**SANTA CLARITA VALLEY WATER AGENCY
NOTICE TO PLANHOLDERS**

ADDENDUM NO. 1

Project: T7, U4, U6 Wells PFAS Treatment, Saugus 1 and Saugus 2 Wells VOC Treatment and New Disinfection Facility Project

DATE: JANUARY 2024
PROJECT NO. SCVWA: 2400420
SHEET: S-11

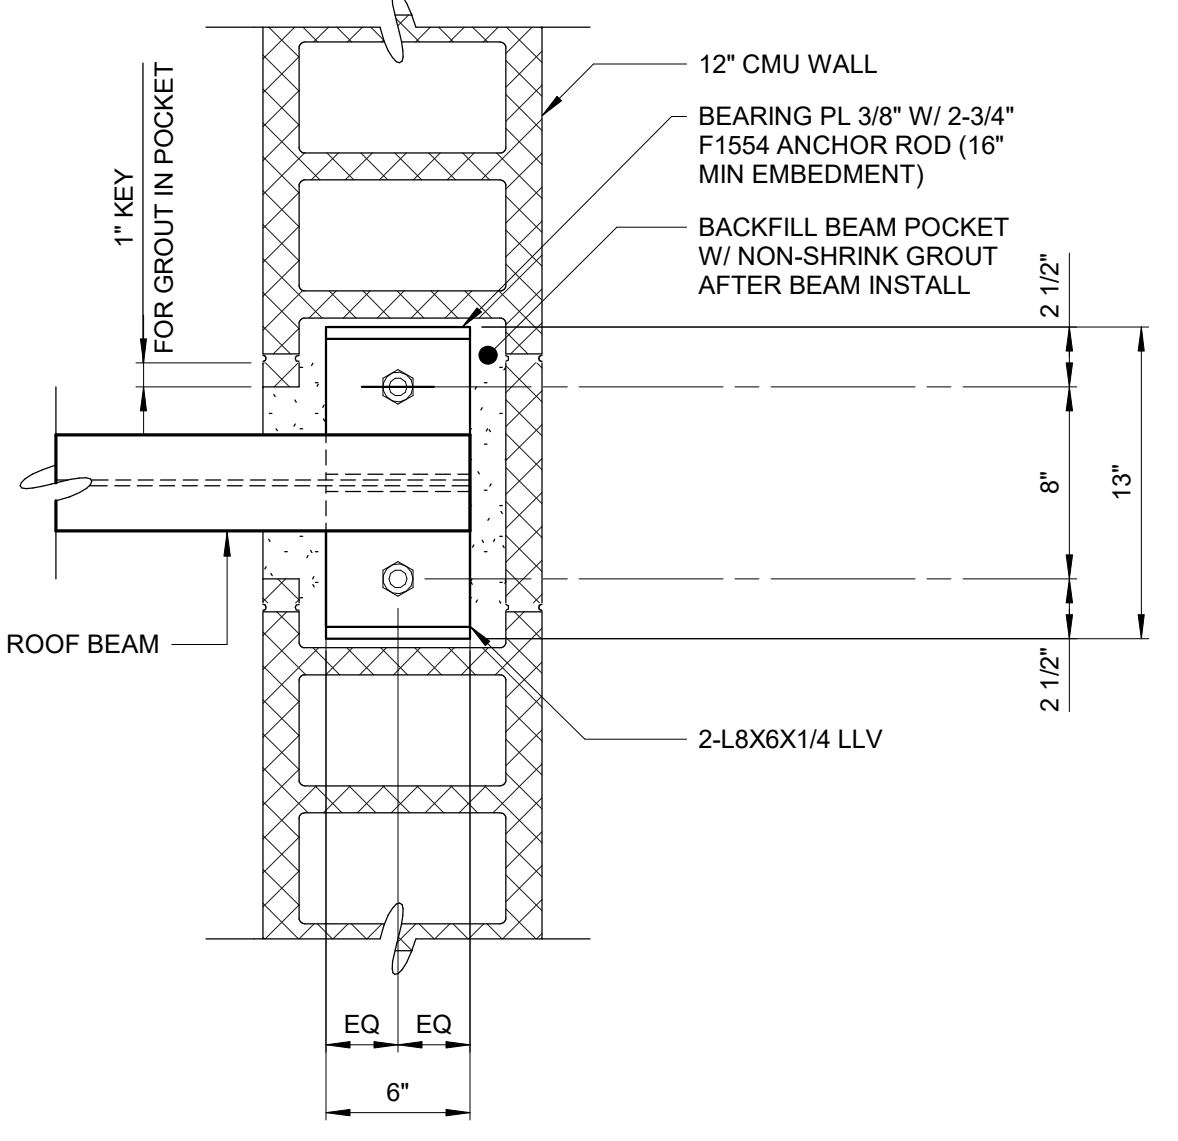
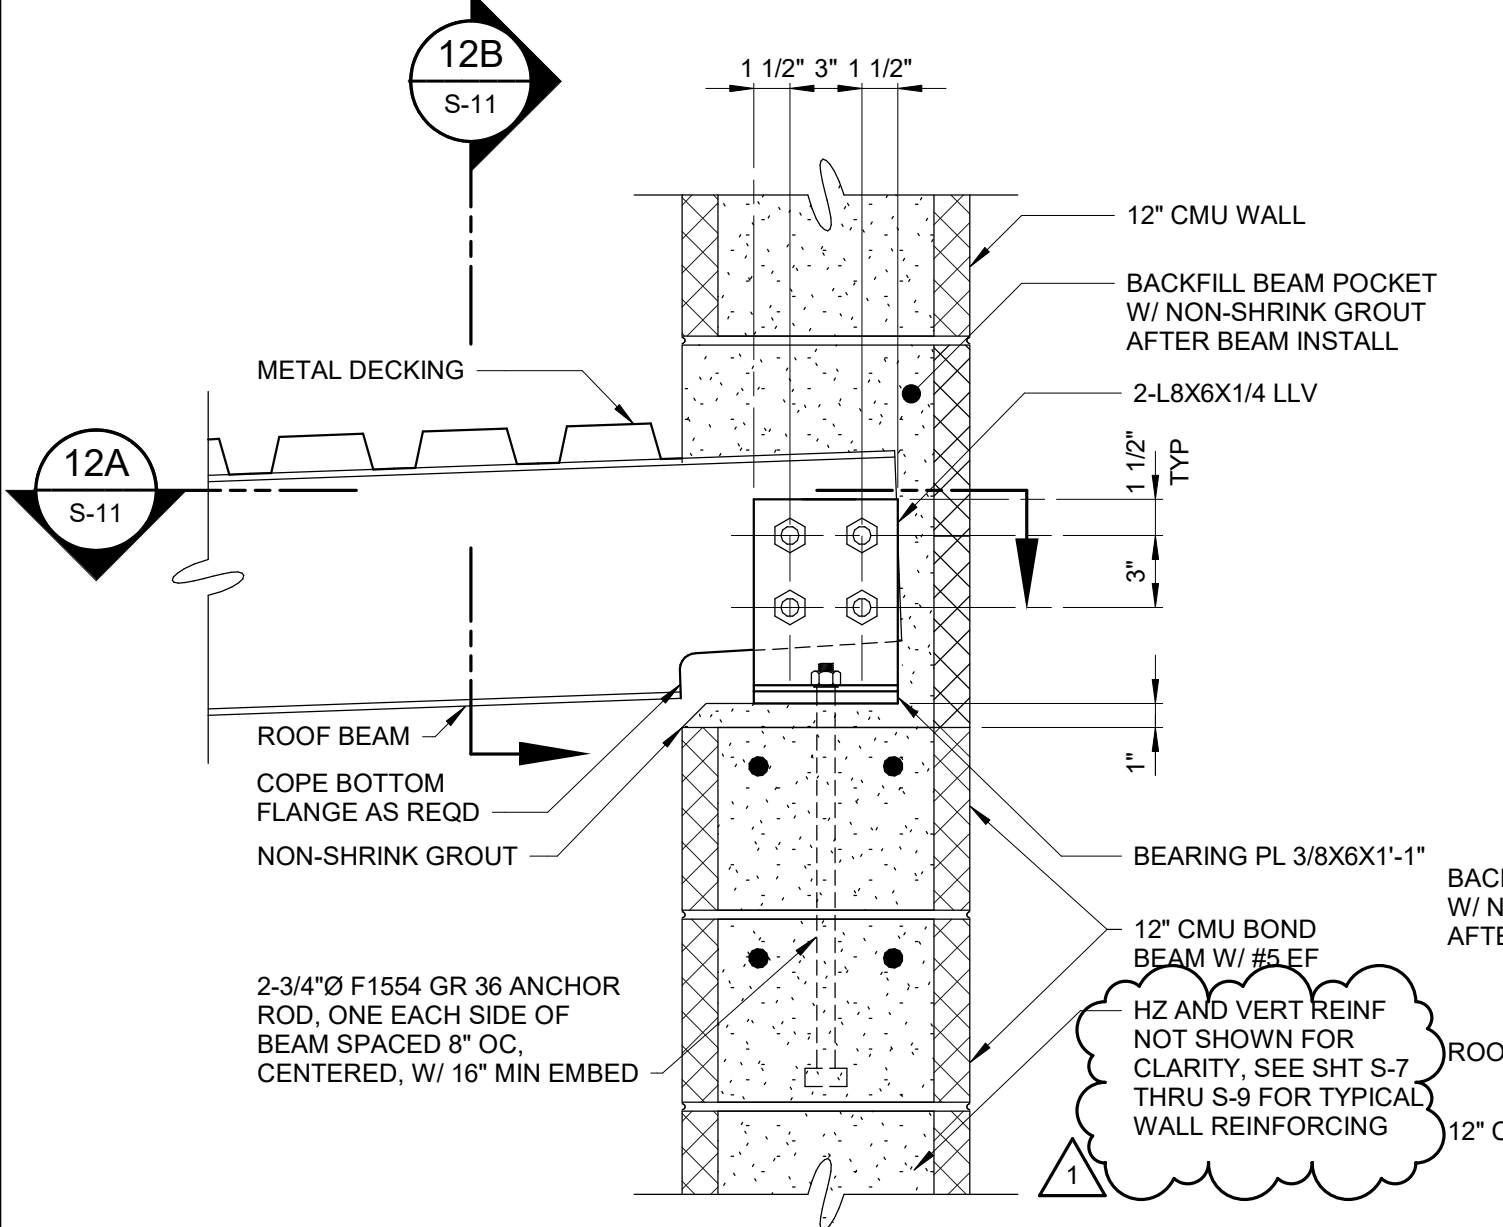
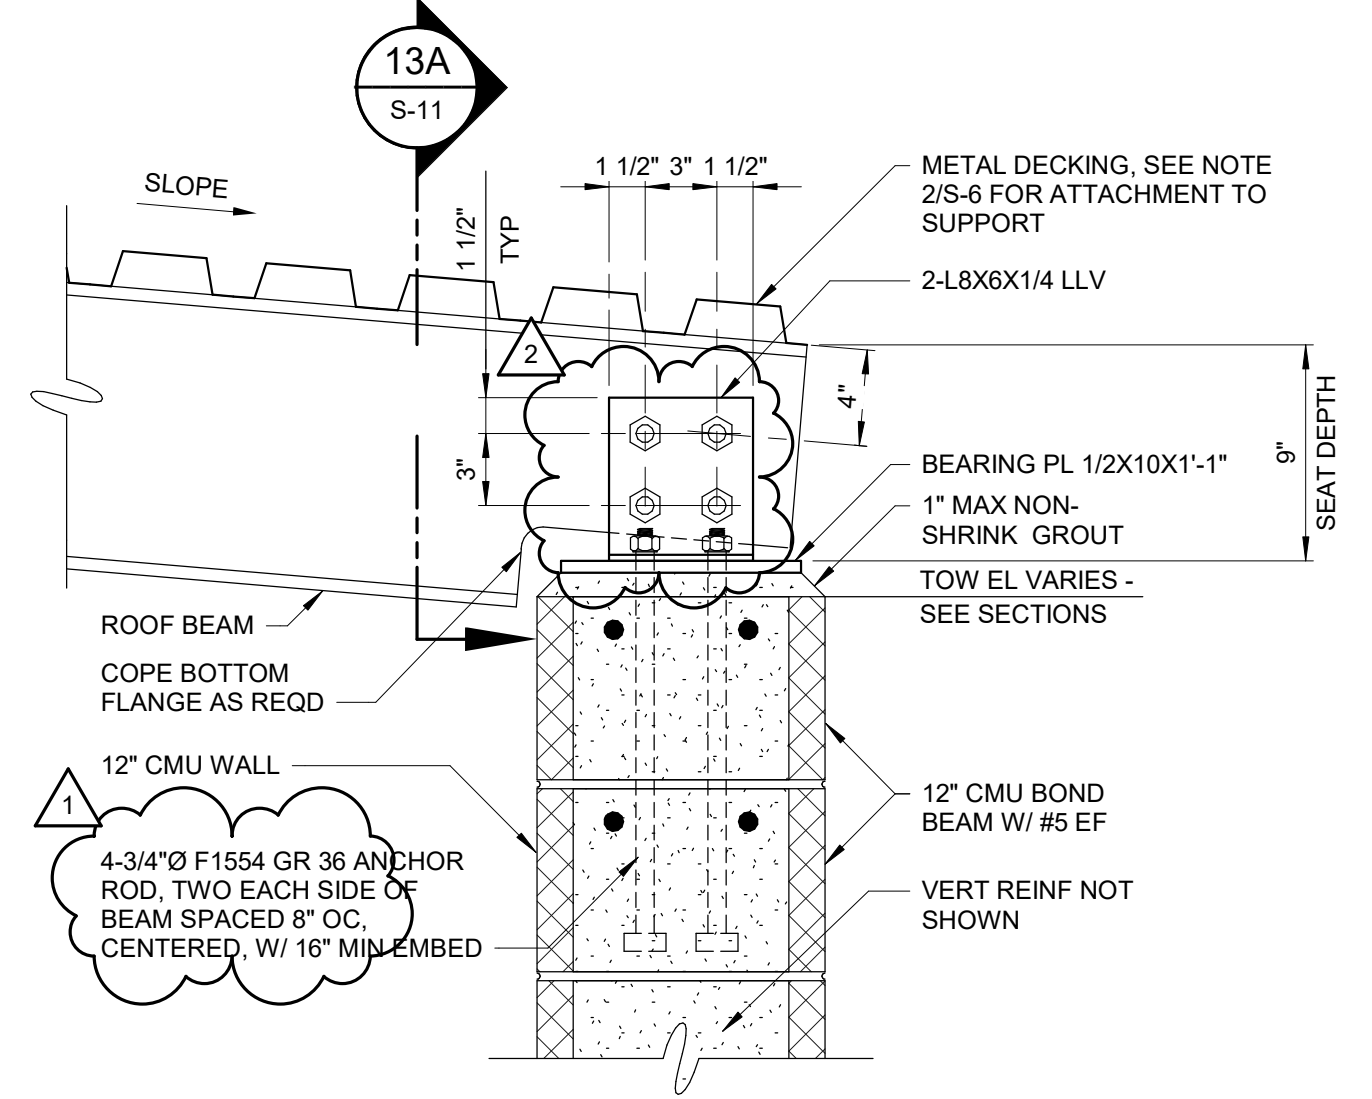
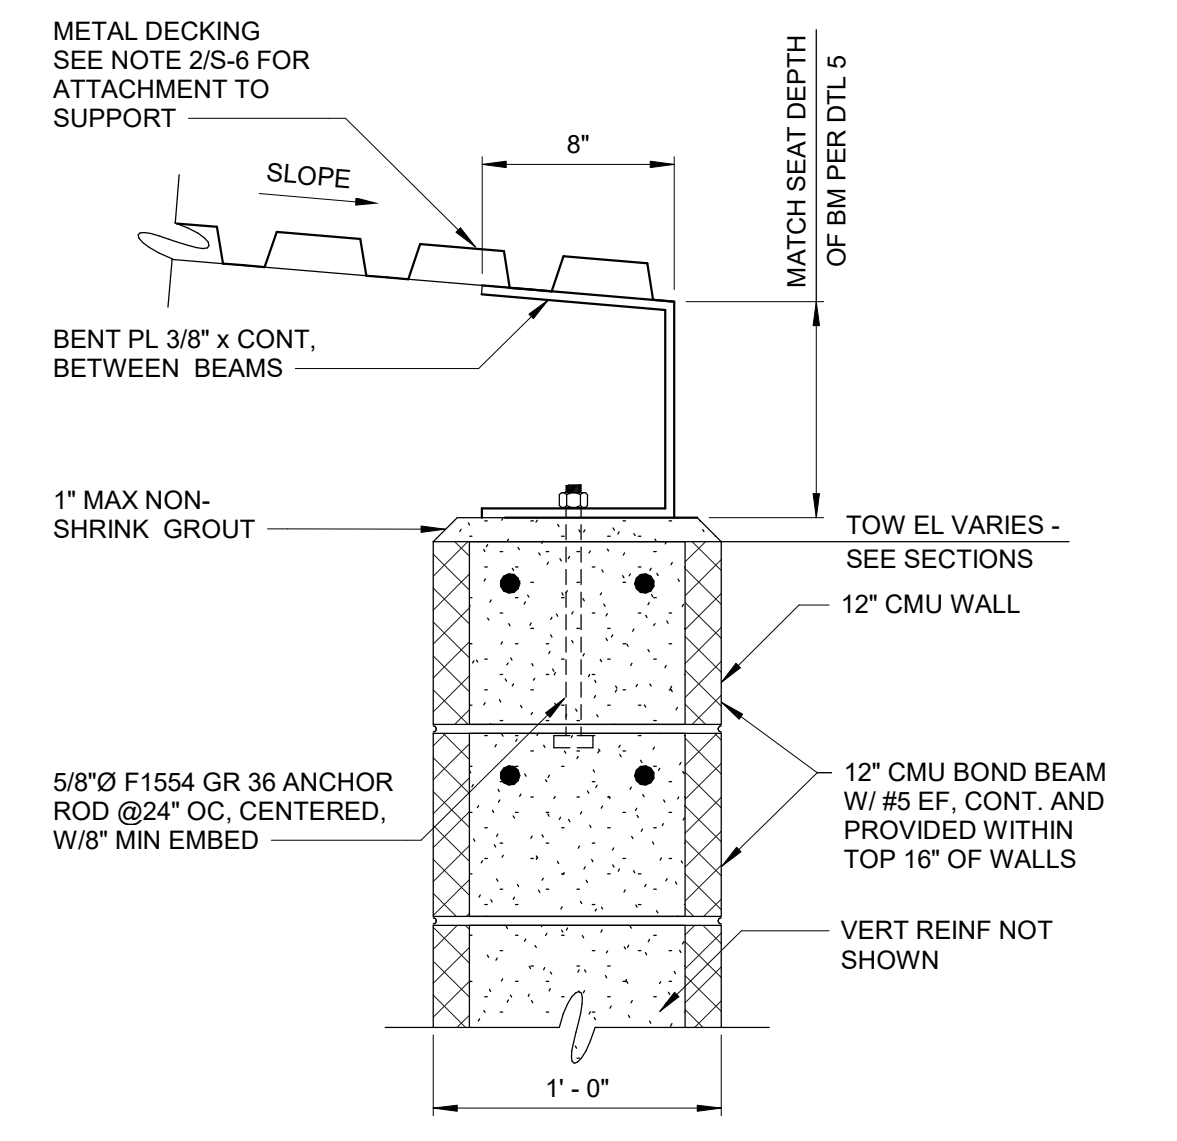
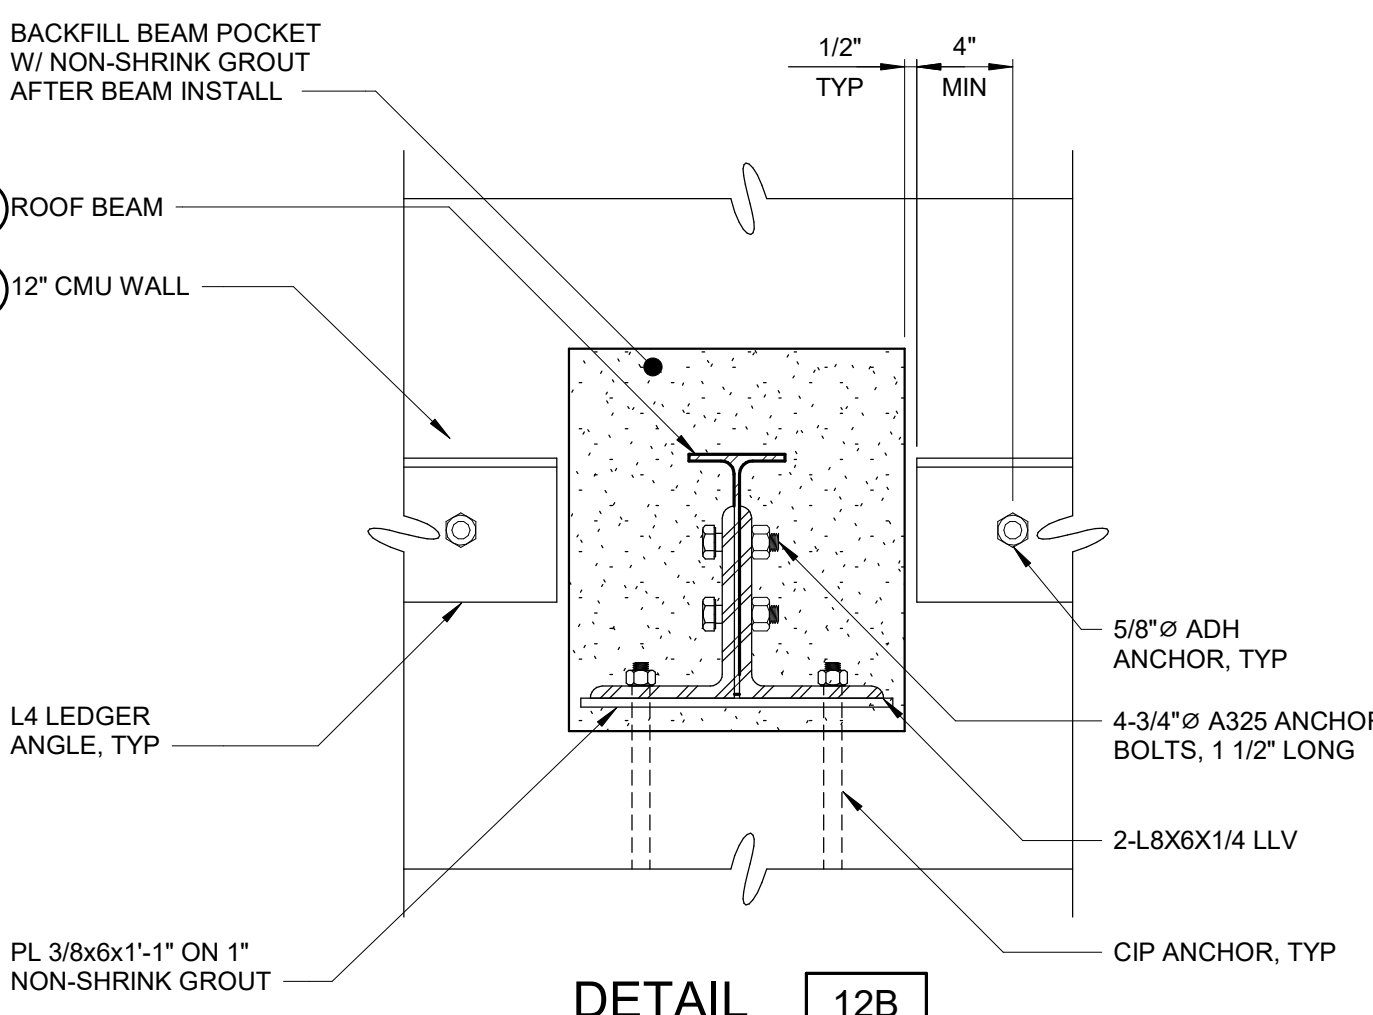
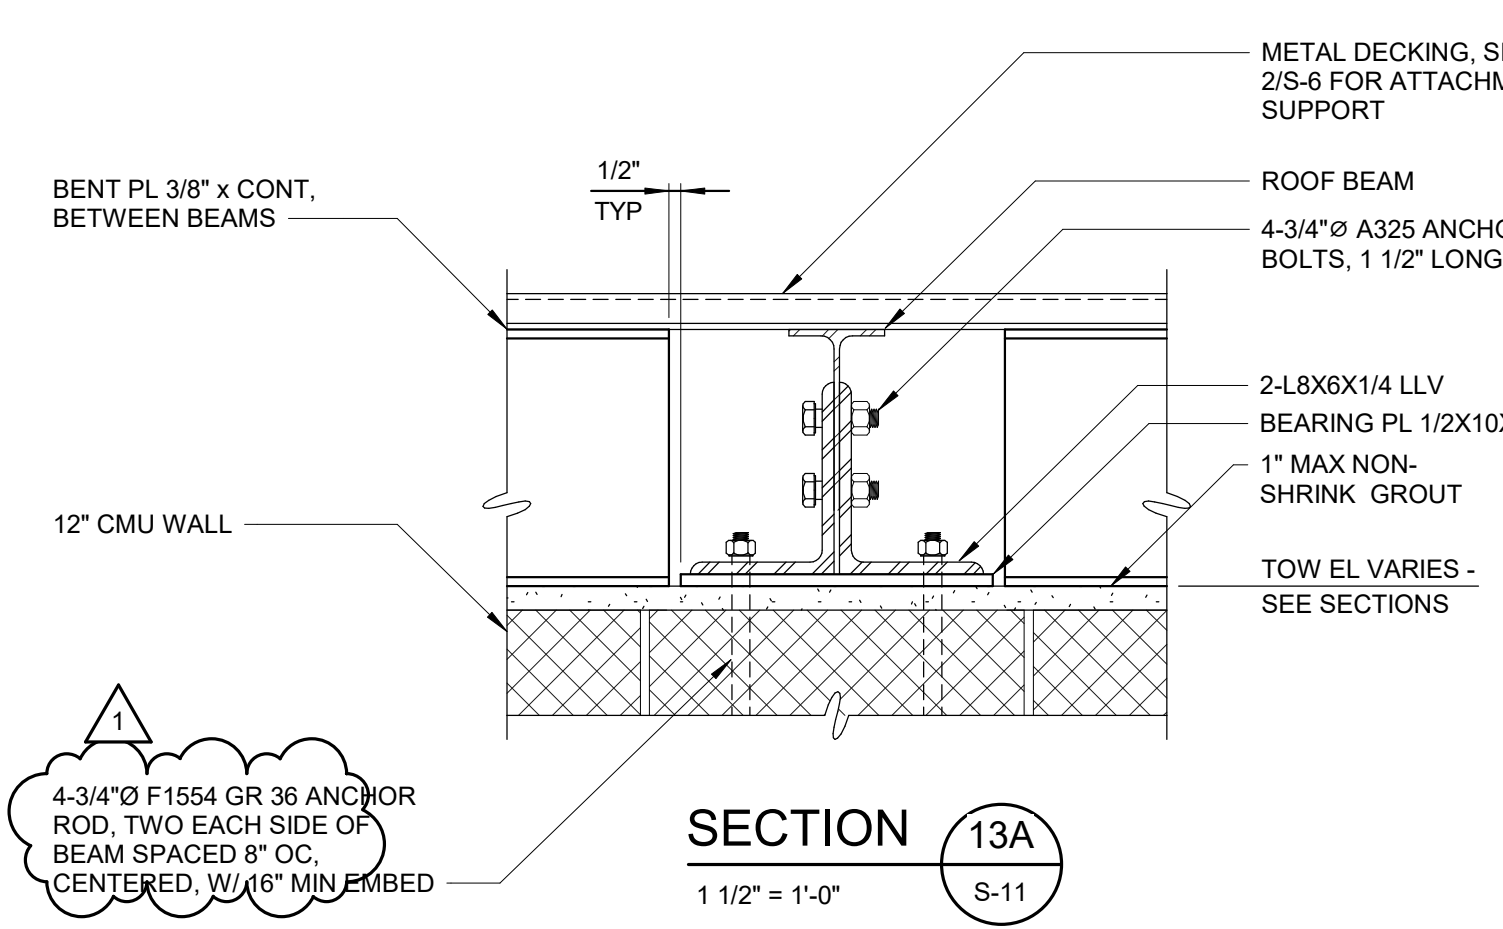
REPLACE Drawings M-10, S-1, S-4, S-5, S-6, S-9, S-11, A-1, A-5, A-6, and A-7 with the REVISED drawings attached.
